M4 Corridor around Newport

Environmental Statement Supplement

Volume 1: Main Text

At Issue | September 2016

Appendix 2.4 Figure 3: Cumulative Carbon Emissions for the Scheme after 20 years (5 years Construction and 15 years Operation – Year 2037)

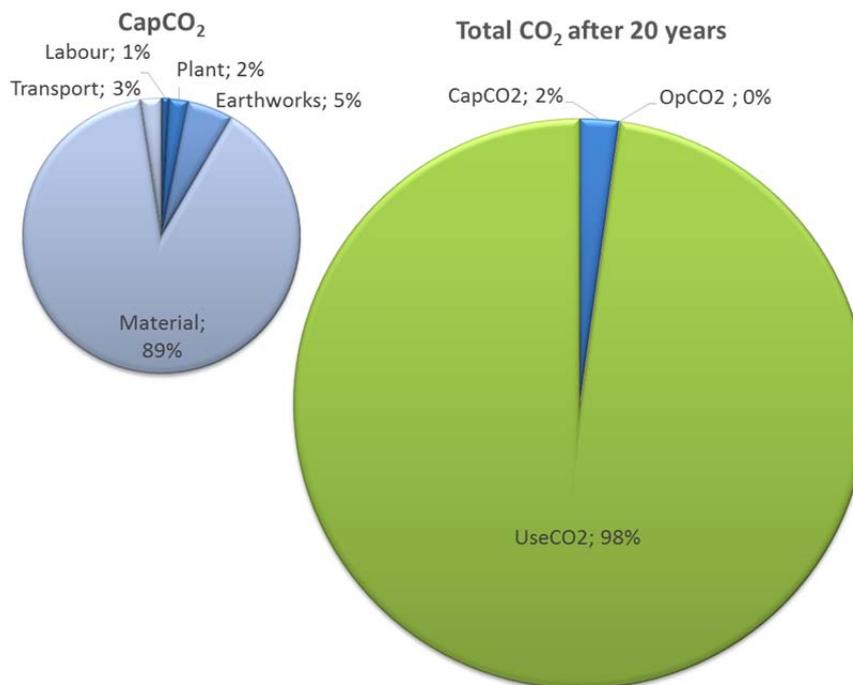
- 2.1.13** Figure 3 was omitted from Appendix 2.4. This is provided below.
